SUSQUEHANNA - UNIT 1

8608110186 860805
PDR ADOCK 05000387
PDR

1.0. DEFINITIONS

MAXIMUM AVERAGE PLANAR LINEAR HEAT
GENERATION RATE (MAPLHGR) VERSUS
AVERAGE PLANAR EXPOSURE
GE FUEL TYPES 8CR233 (2.33% ENRICHED)
FIGURE 3.2.1-1

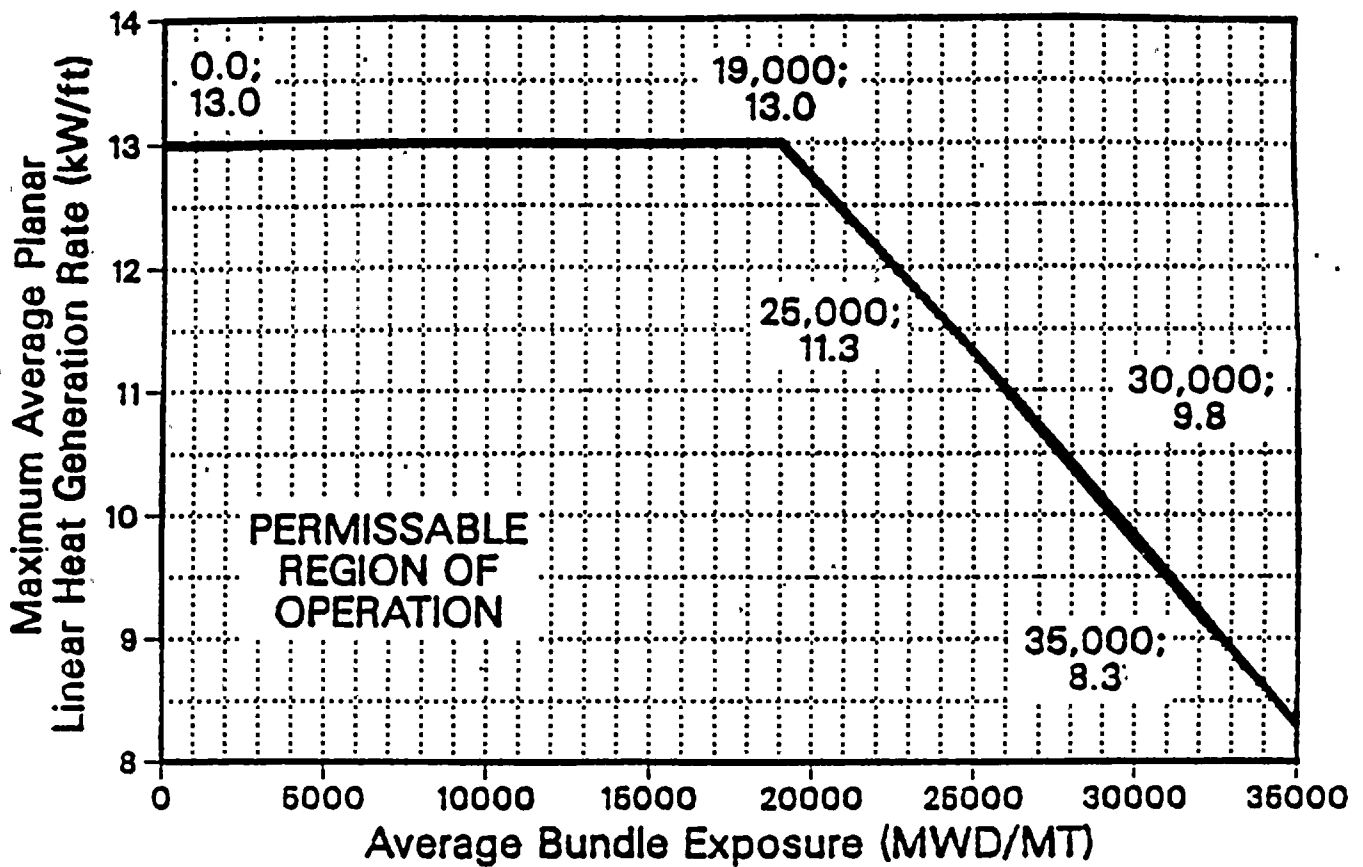
DELETE

FIGURE 5.1.1-1

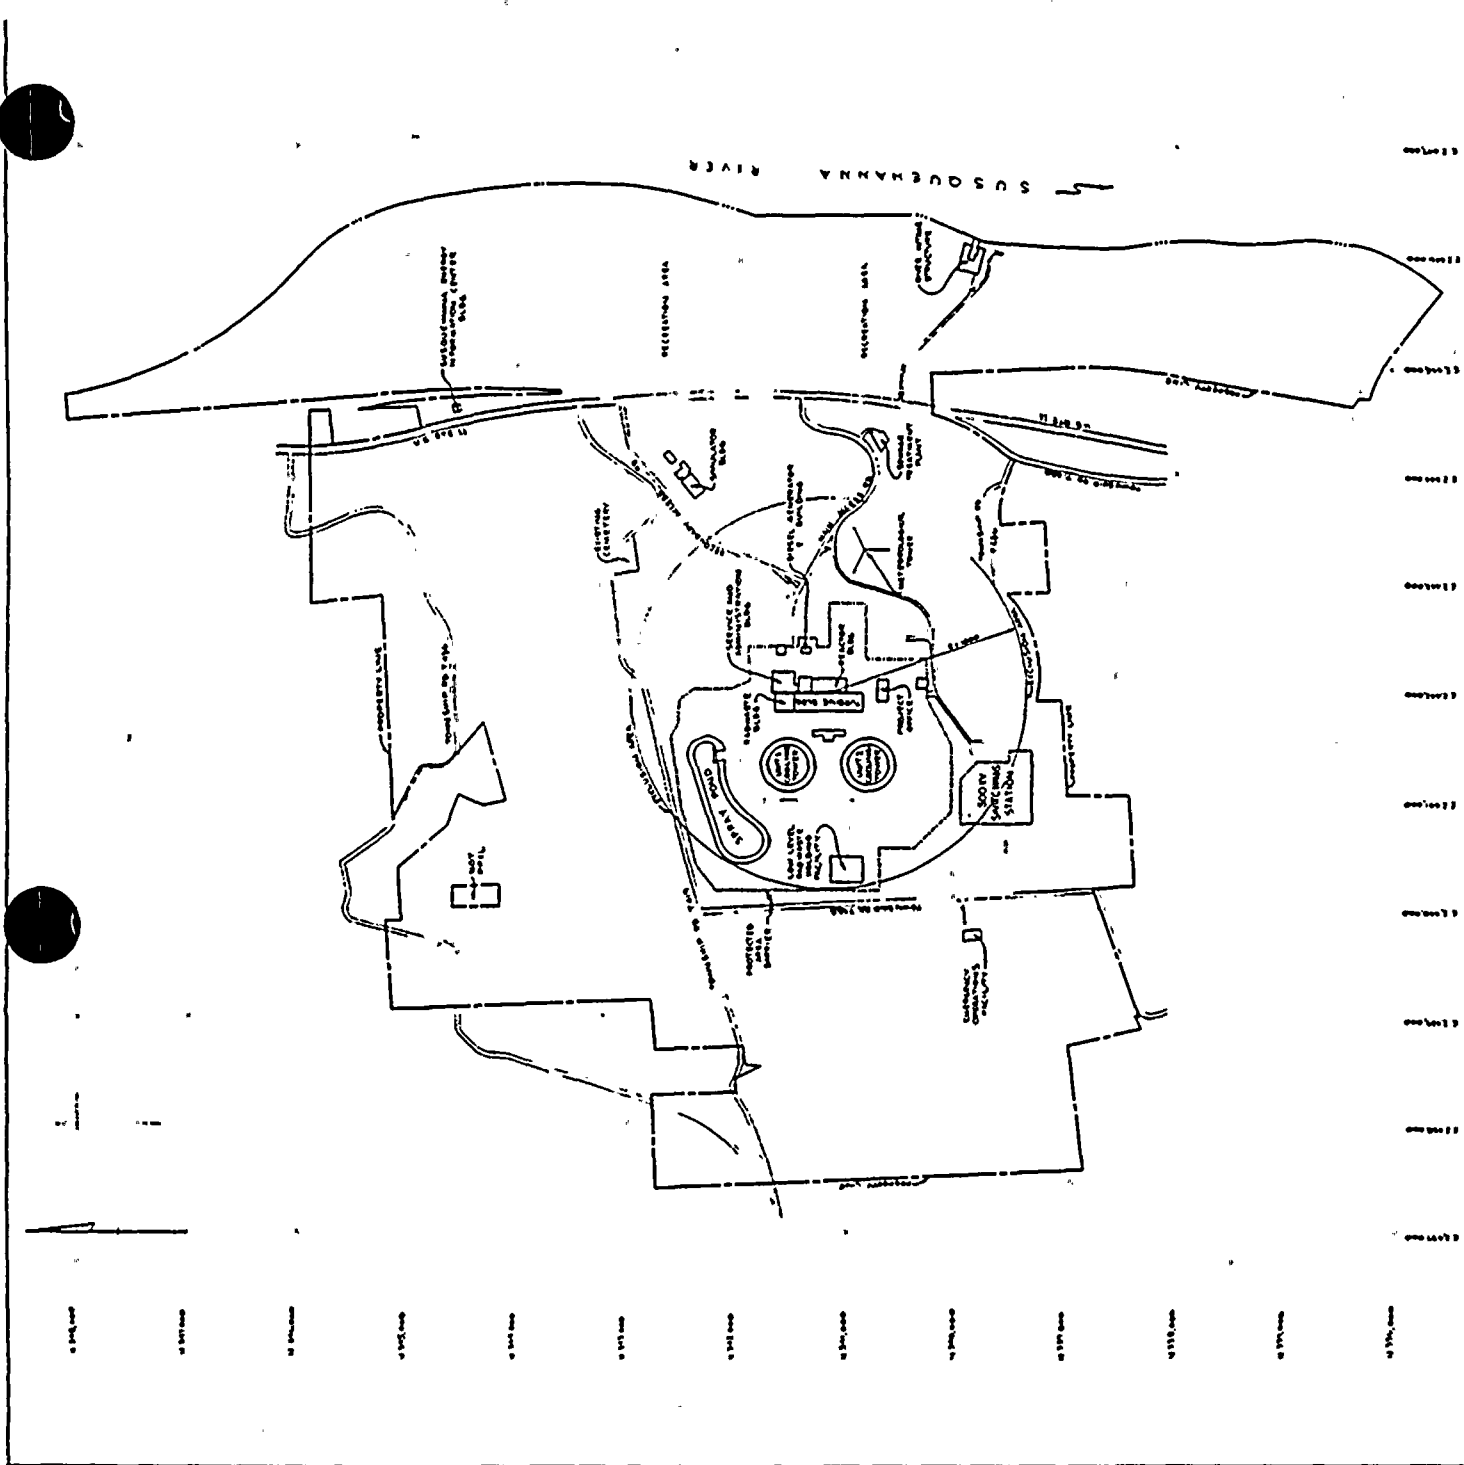
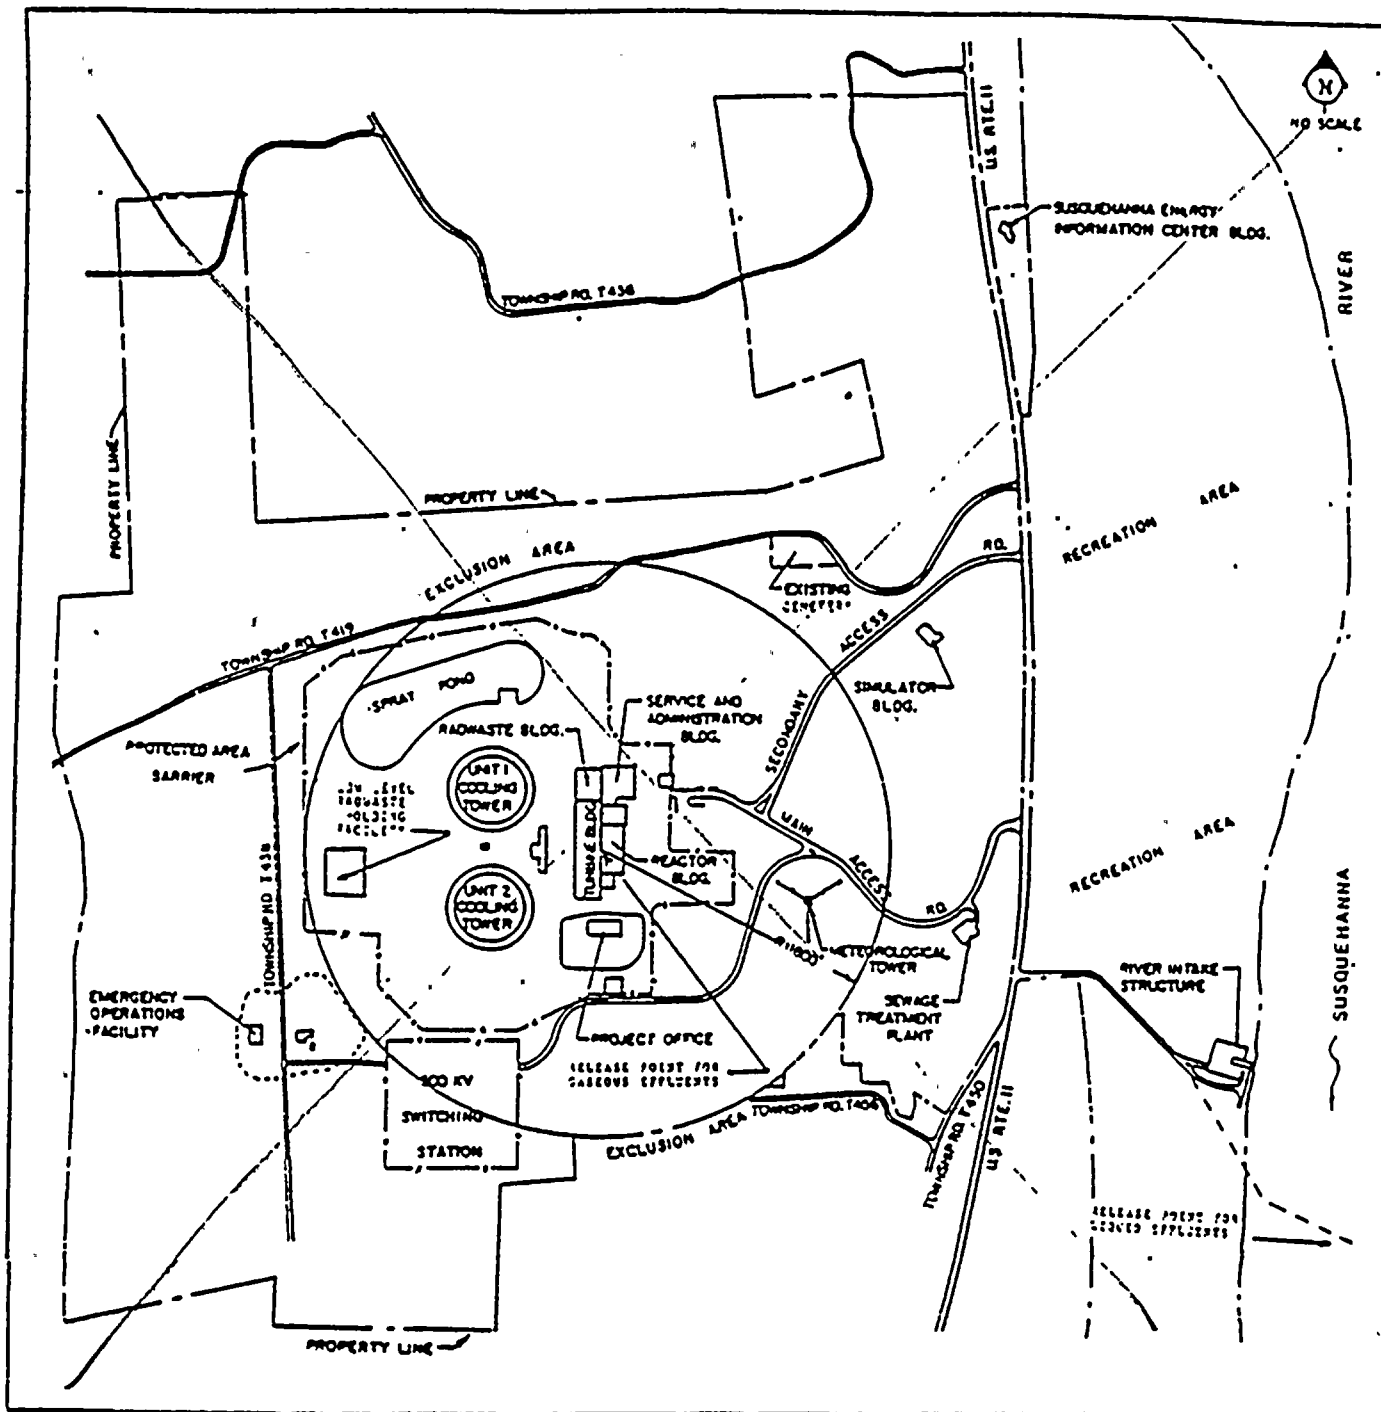
REPLACE WITH NEW FIGURE, ATTACHED, :

FIGURE 5.1.3-1a

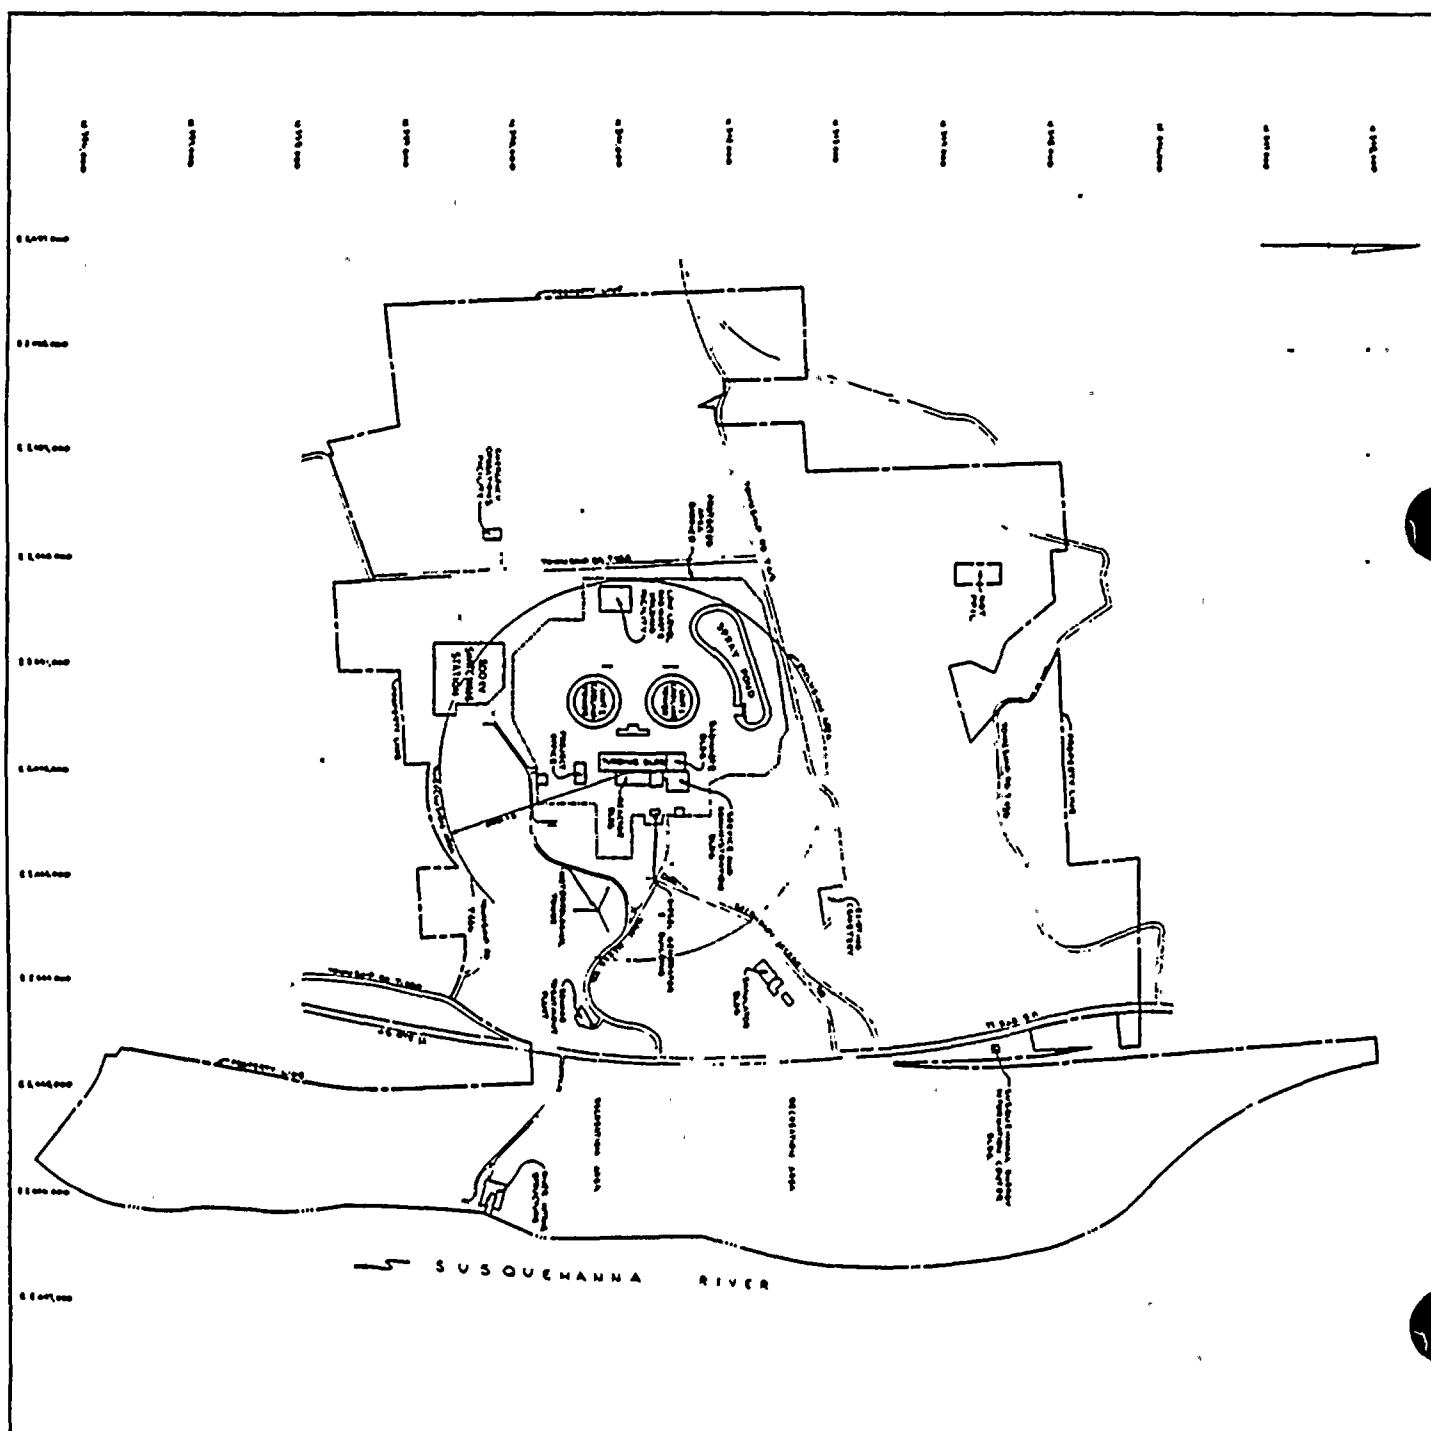
REPLACE WITH NEW FIGURE, ATTACHED

FIGURE 5.1.3-1a

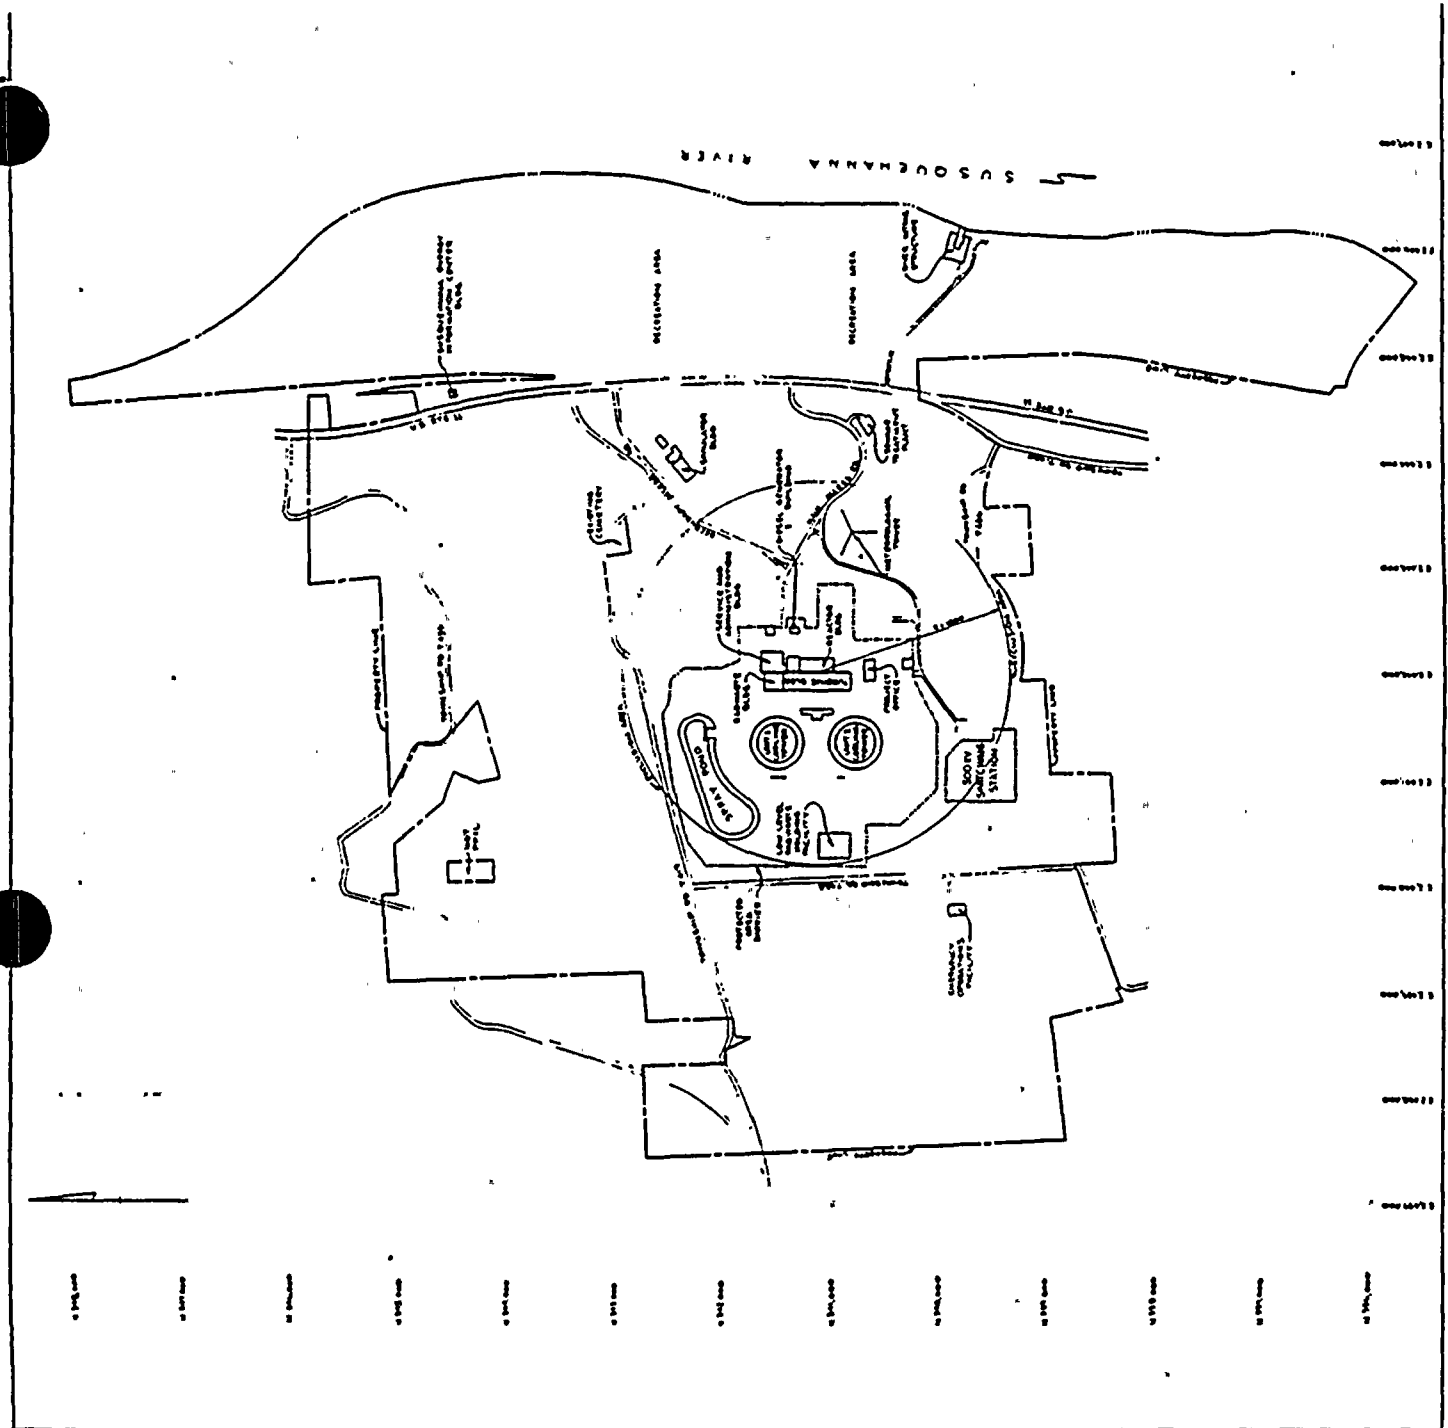
REPLACE WITH NEW FIGURE, ATTACHED
